IMPORTANT SERVICE LETTER

NUMBER: SL-002 **DATE:** 4/23/2012 Revision: 01

SUBJECT: DOOR ASSEMBLY - New Latch Handle Assembly

Figure 2 - Remove the Handle Roll Pin

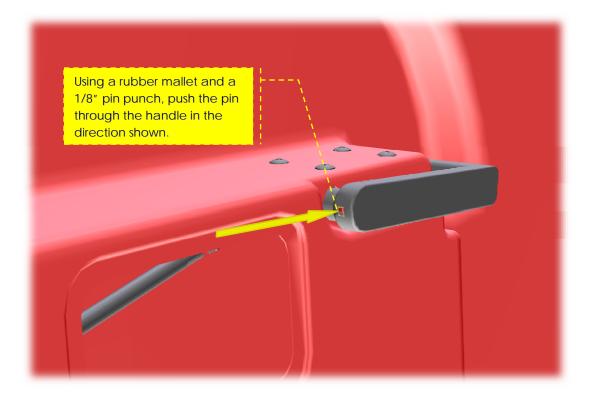
2. The next step is to remove the handle from the door. Using a hammer and a 1/8" pin punch, tap the roll pin through the handle bracket assembly. See *Figure 2*.

Figure 3 - Remove the Handle

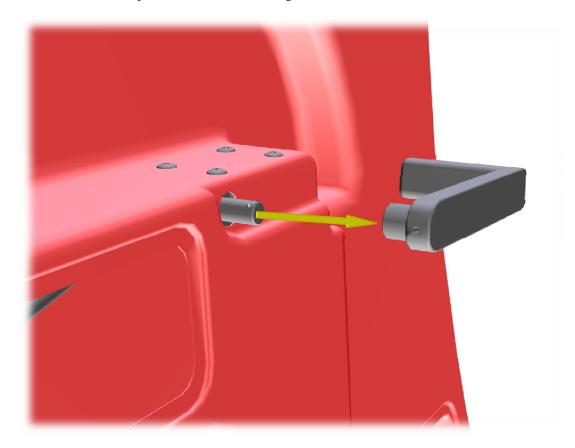
3. Once the pin is removed, the handle can be removed by pulling it away from the door. See *Figure 3*.

Figure 4 - Disconnecting the Tie Rod

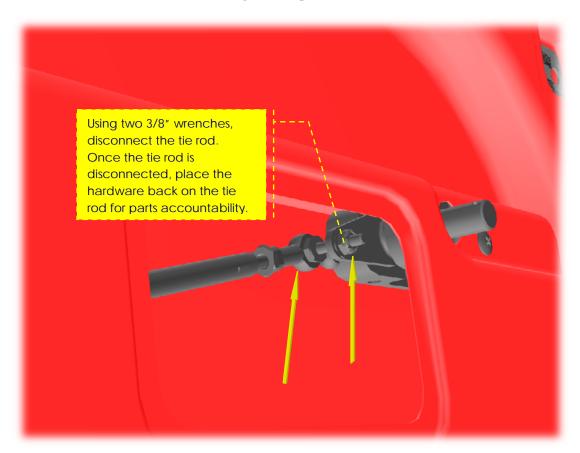
4. The next step is to unbolt the tie rod that connects to the handle bracket assembly. See *Figure 4*.

Figure 5 - Removing the Screws

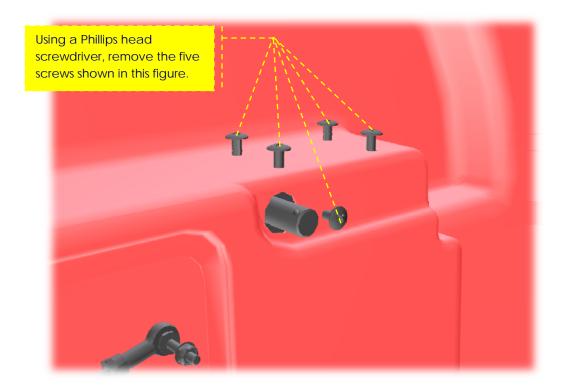
5. After the tie rod is disconnected. Remove the five Phillips screws holding the Latch Handle Assembly to the door. See *Figure 5*.
